Amendments to the Drawings

Fig. 1

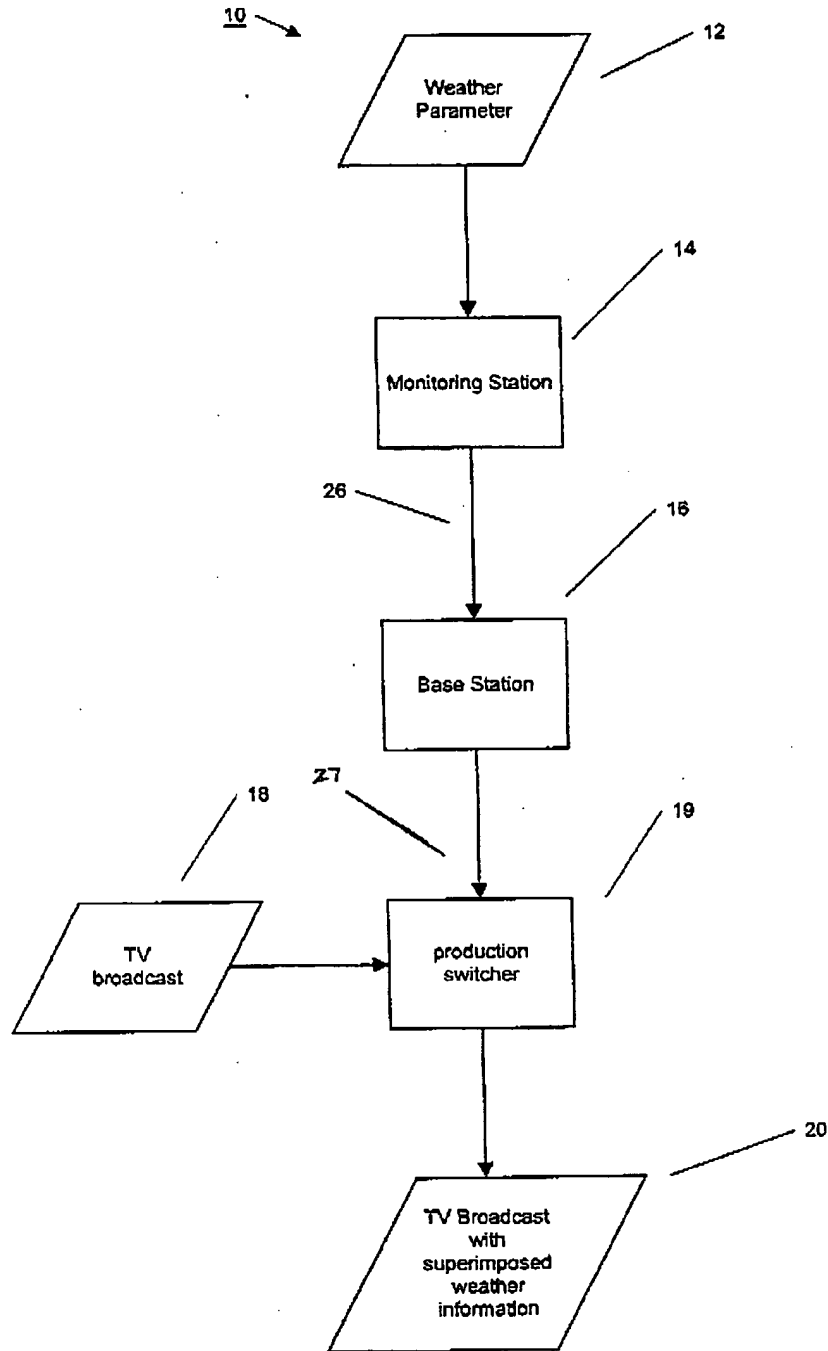
The attached drawing sheets include changes to Figures 1 and 9. Figure 1 has been amended to include a reference to "link 27." Figure 9 has been amended to correct the duplication of element "81"; more specifically, signal path "81" has been amended to read signal path "80." All figures within the subject application are now believed to comply with 37 C.F.R. §1.84.
